Albert Street Cavern Assessment Report Albert Street - Future Over Station Development Brisbane, QLD

Document Reference:
B01493-IBS

Addendum 1: Response to ARUP comments

Figure 7 – Ground Loads (PSM3700-1102M)

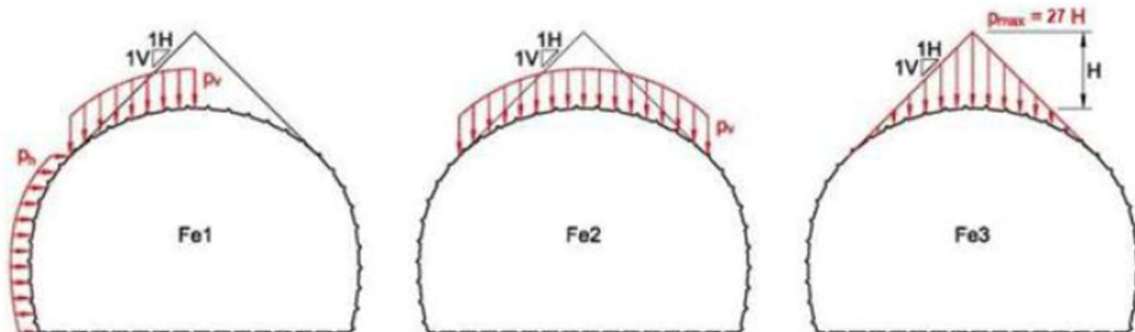
Observation and Comments - TMR Structures		
Section 3.6 - Figure 4 corresponding to Table B2-B for case 2 is missing.	This is the distortion case associated with Load Case7, see response below.	Closed

Analysis Group I (Ia) - Change in Vertical Displacement on Cavern Liner

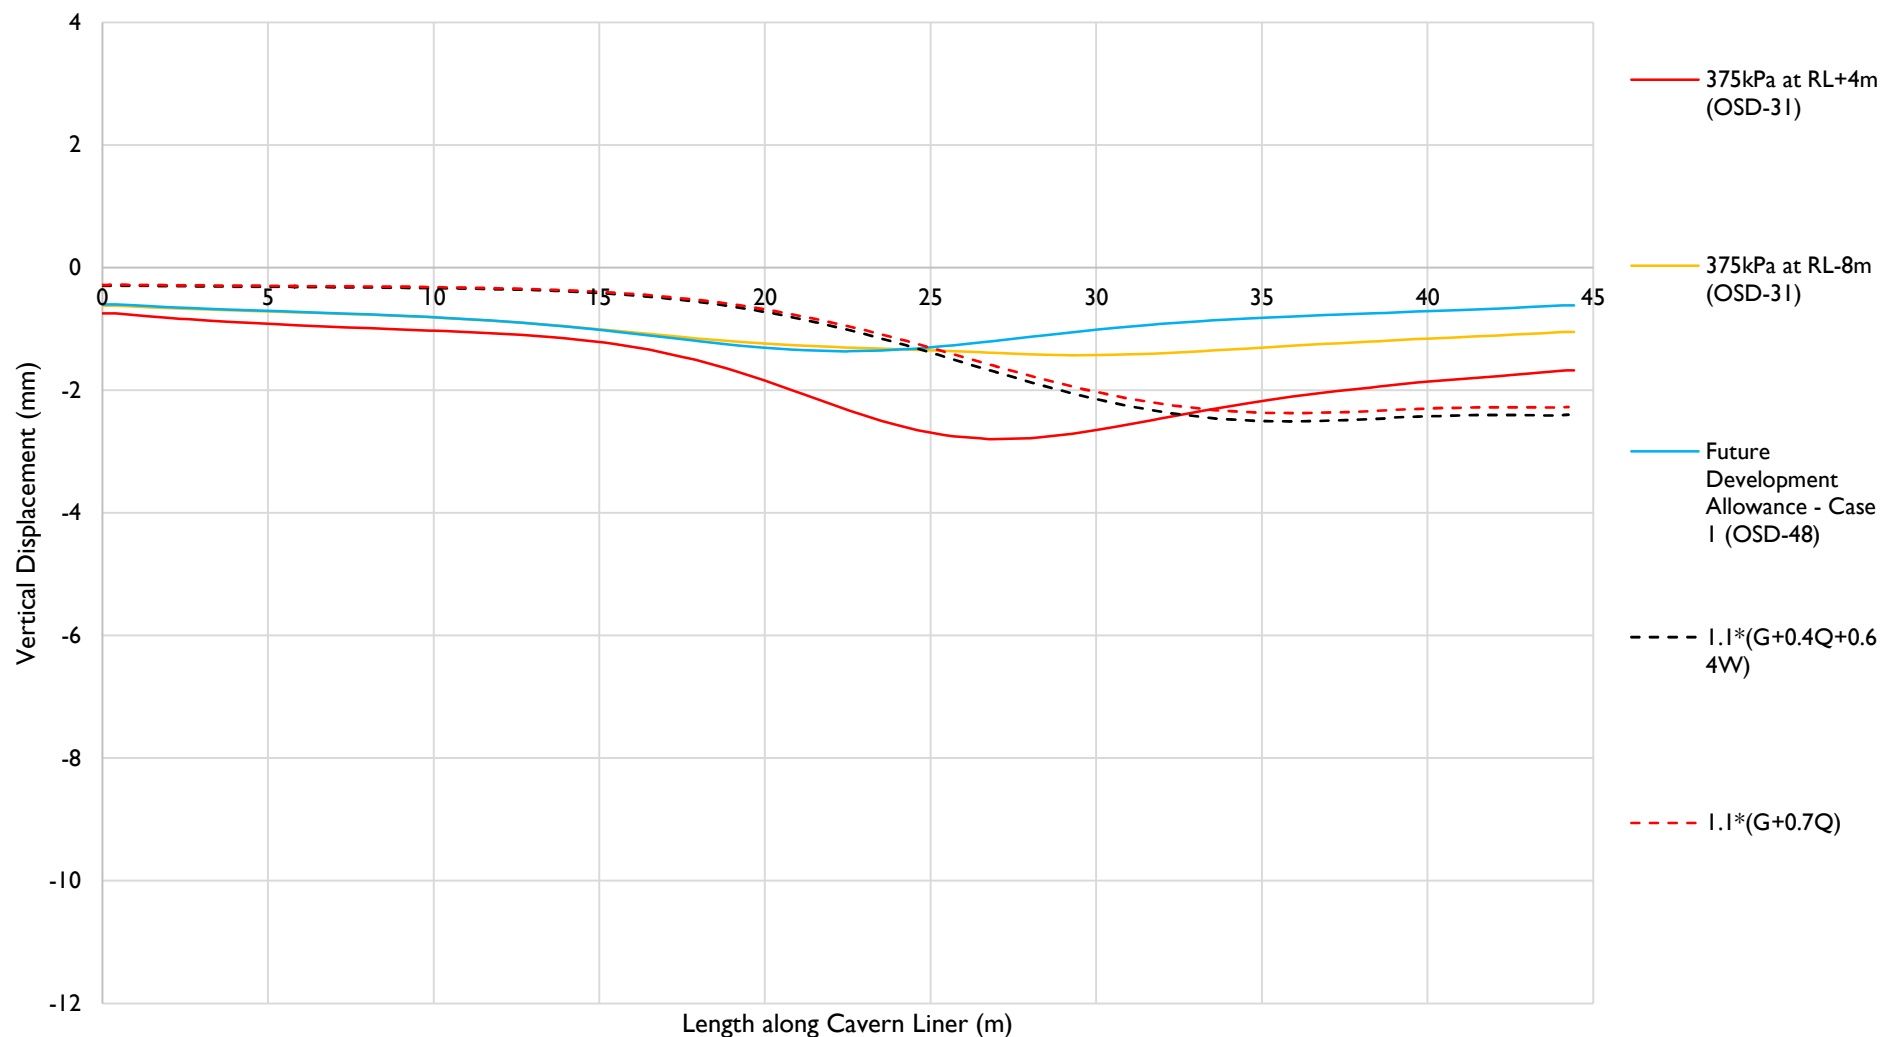
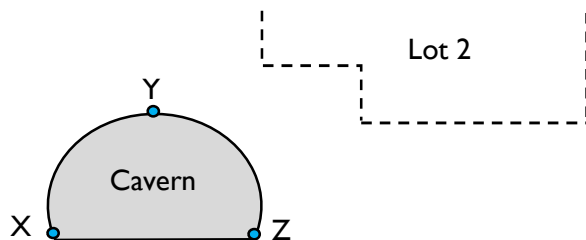
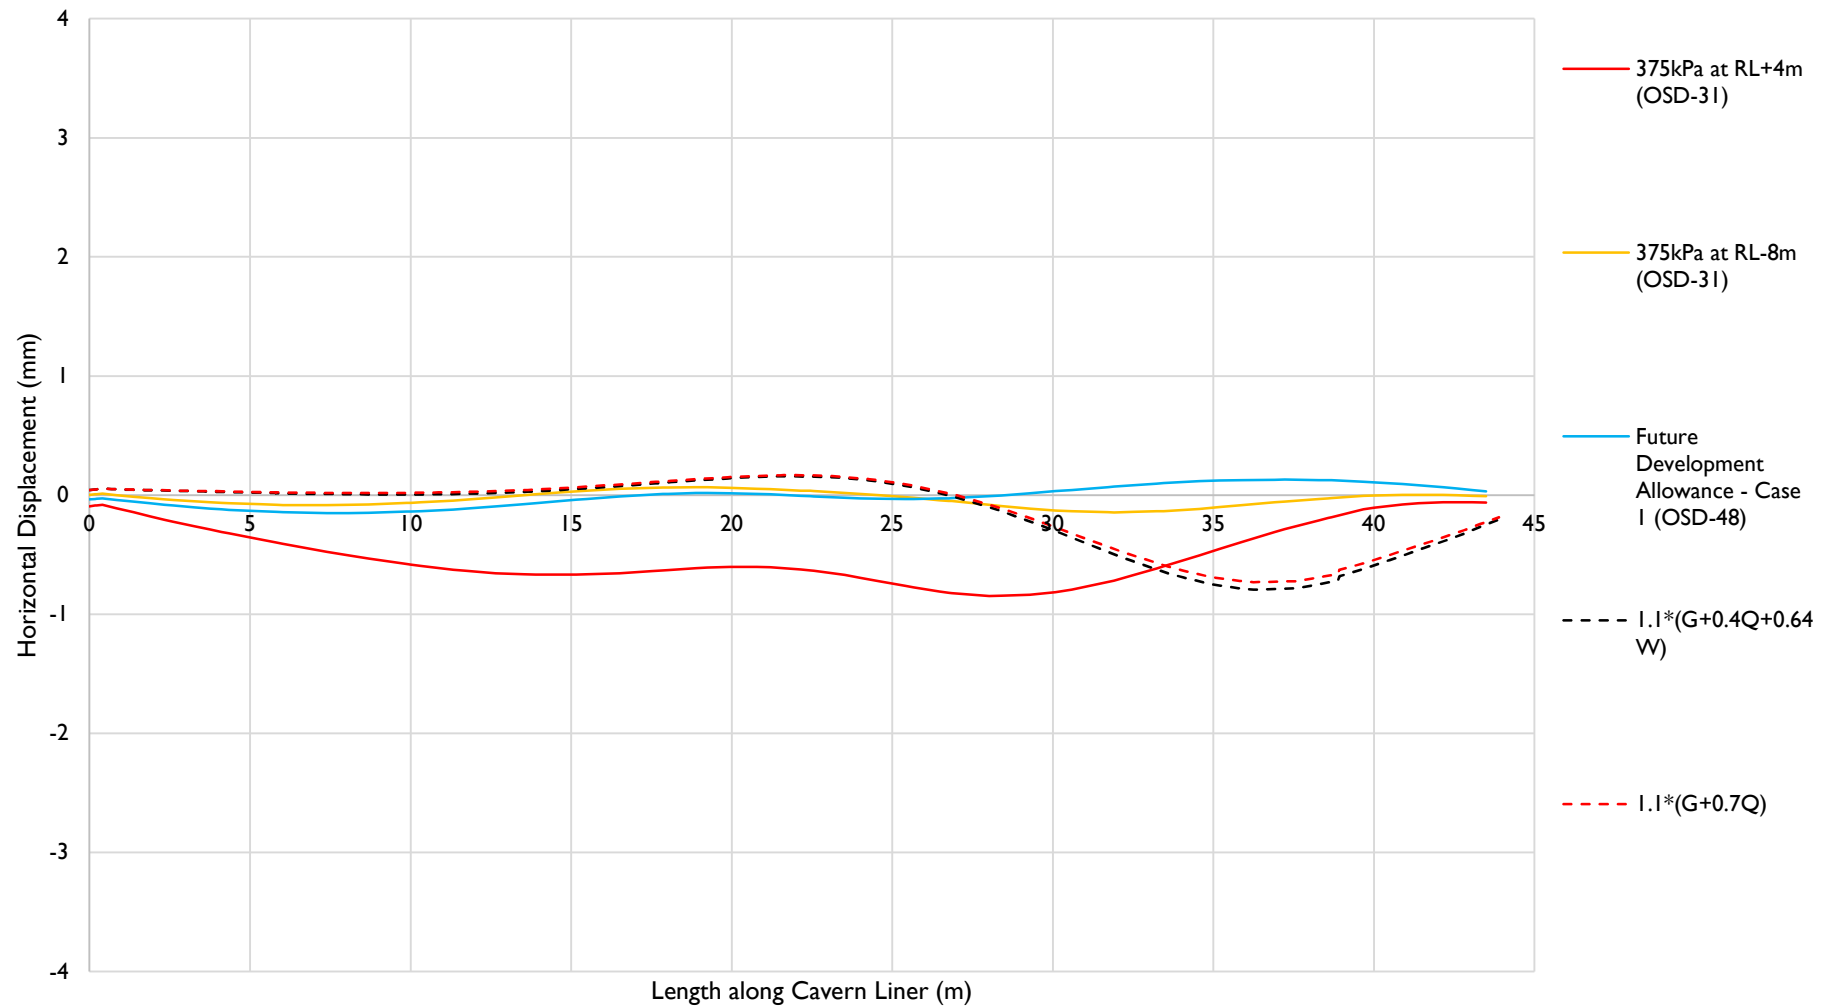
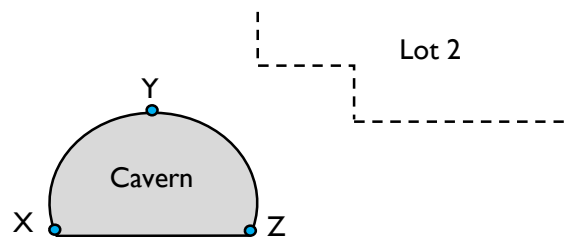
EDG should include a longitudinal section of the tunnel showing the expected displacements along the cavern at positions X, Y and Z. This would facilitate the design of appropriate instrumentation to monitor and validate the predicted movements.	A longitudinal section showing the predicted cavern displacements will be extracted from the results and used to define trigger levels and the cavern monitoring plan.	Closed
